B	TP	M TOWNSEND
12/31/2007	ECN-84646

samtec

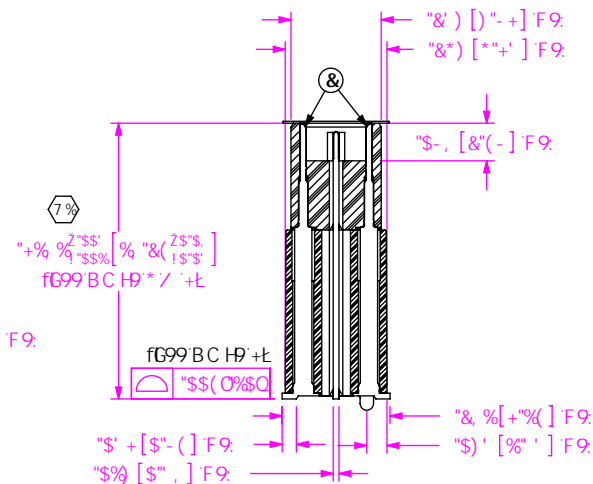
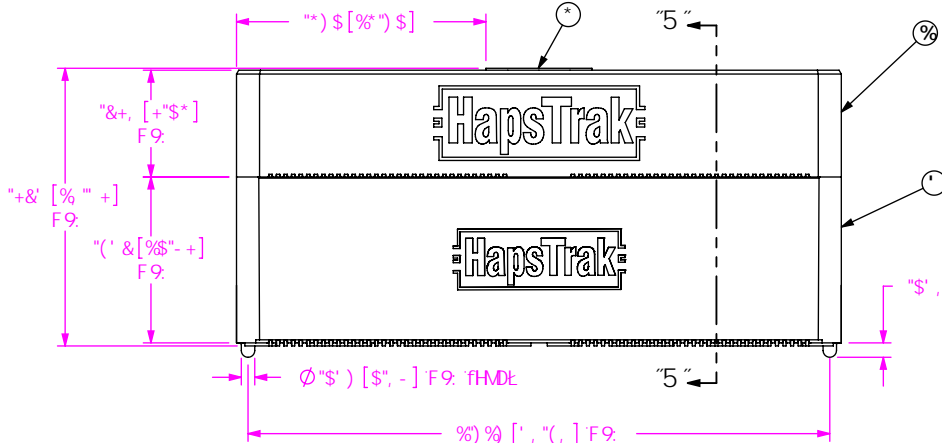
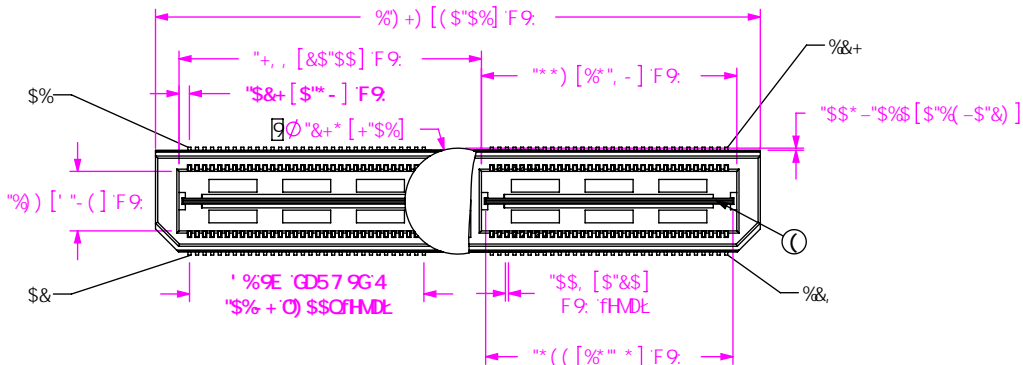
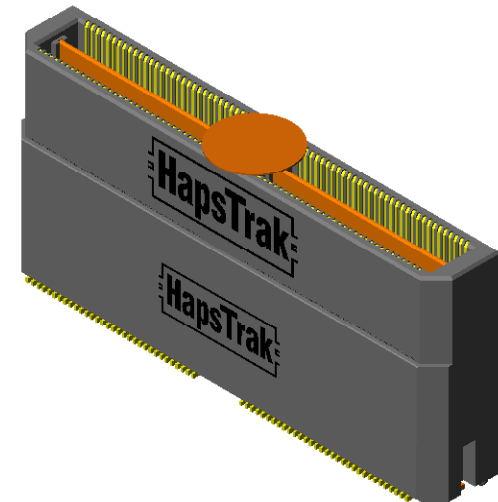
RELEASE FOR PRODUCTION. ADD
 "HAPSTRAK" LOGO TO ITEM 1; NOTES
 CHG NOTES FROM "...GROUND PLANE
 RETENTION..." TO "...GROUND PLANE
 RETENTION..."; TOP VIEW. CHG 127 PIN
 NUMBER TO 128. CHG 128 PIN NUMBER TO
 127. ADD .005 DIM FRONT VIEW. DEL .268
 REF DIM. ADD .278 REF DIM. ADD .723 REF
 DIM. ADD .275 DIA REF. ADD .650 DIM. BOM
 ADD ITEM#

BOM: CHG ITEM 2 FROM T-1S60-05-L
 TO ASP-137246-05-P-L & CHG ITEM 4
 FROM T-1G1-05-G TO ASP-137238-10-
 P-G

BOM: CHG ITEM 2 FROM ASP-137246-
 05-P-L TO T-1S60-05-L. CHG ITEM 4
 FROM ASP-137238-10-P-G TO T-1G1-
 05-G

BOM: CHG ITEM 4 FROM "T-1G1-05-G"
 TO "T-1G1-05-L"; PLATING SPECS:
 CHG: "000003 GOLD..." TO "000200
 MATTE TIN..."

BOM: CHG K-500-300 TO K-DOT-276-
 375-.005
